# UNITED STATES PATENT AND TRADEMARK OFFICE

APPLICATION NO.	FILING DATE	FIRST NAMED INVENTOR	ATTORNEY DOCKET NO.	CONFIRMATION NO.
10/543,173	07/22/2005	Masaki Yamada	274300US2PCT	7941

<b>Office Action Summary</b>	<b>Application No.</b> 10/543,173	<b>Applicant(s)</b> YAMADA ET AL.	
	<b>Examiner</b> DANIEL CAVALLARI	<b>Art Unit</b> 2836

### **DETAILED ACTION**

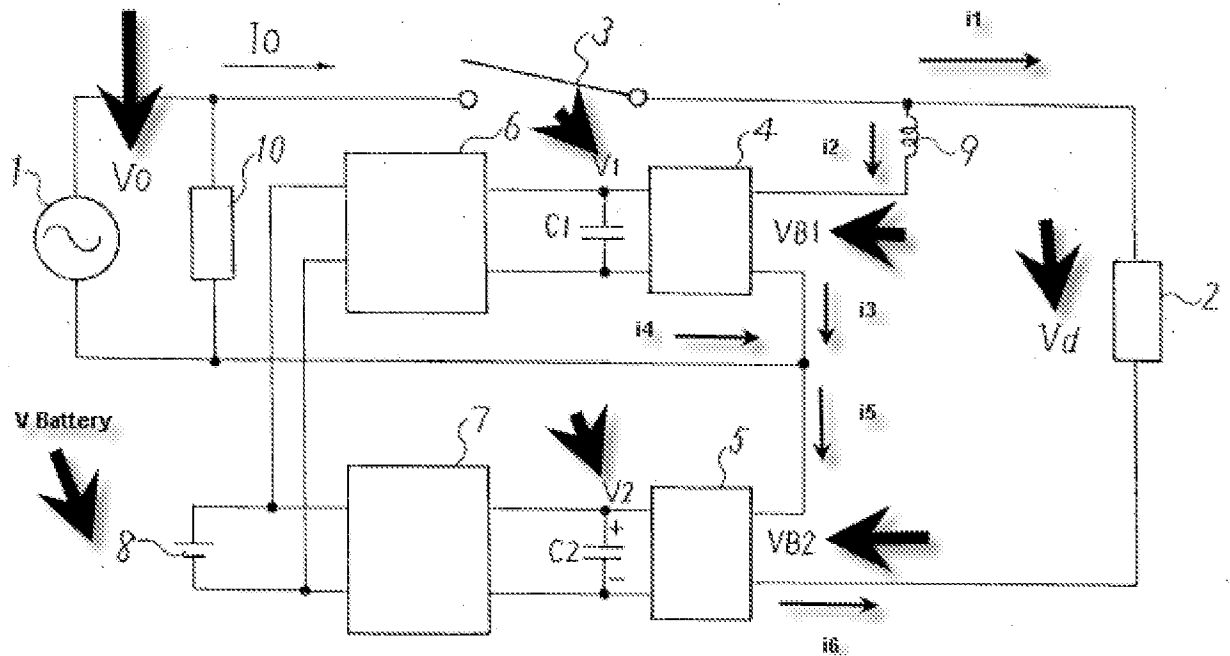
Looking at applicant's invention (as shown in Figure 1 below), the provided connections cannot be defined as "parallel" and "series" as claimed. To highlight this point, the varying currents (represent by i1-i6) and voltages (voltages pointed out with the large arrows) which do not thereby meet the well known and established "parallel" and "series" connection definitions as defined in the art are illustrated (see definitions provide above).

The claim states “to supply the electric power to the load by superimposing their output voltages” however it is unclear where the “superimposing” of output voltages occurs in applicant’s invention. It appears that the “superimposing” occurs at the load itself and therefore the signals are not actually superimposed on each other but rather create a potential between the load (2) (see figure 1 above).

The drawings are objected to under 37 CFR 1.83(a). The drawings must show every feature of the invention specified in the claims. Therefore, the particular interconnections of the converters (4, 5, figure 1) must be shown or the feature(s) canceled from the claim(s). No new matter should be entered.

Since the particular interconnection of the device is explicitly claimed, the drawings must provide an accurate representation of the invention incorporating the specific interconnections of

the converters (4-7). As the claims presently stand, the "series" and "parallel" connection provide the novel component of applicant's invention and are essential in understanding its operation. The present figures do not show the connections as claimed. If the claims are in fact accurate, then the figures should support the particular connections in the claims.

Corrected drawing sheets in compliance with 37 CFR 1.121(d) are required in reply to the Office action to avoid abandonment of the application. Any amended replacement drawing sheet should include all of the figures appearing on the immediate prior version of the sheet, even if only one figure is being amended. The figure or figure number of an amended drawing should not be labeled as "amended." If a drawing figure is to be canceled, the appropriate figure must be removed from the replacement sheet, and where necessary, the remaining figures must be renumbered and appropriate changes made to the brief description of the several views of the drawings for consistency. Additional replacement sheets may be necessary to show the renumbering of the remaining figures. Each drawing sheet submitted after the filing date of an application must be labeled in the top margin as either "Replacement Sheet" or "New Sheet" pursuant to 37 CFR 1.121(d). If the changes are not accepted by the examiner, the applicant will be notified and informed of any required corrective action in the next Office action. The objection to the drawings will not be held in abeyance.
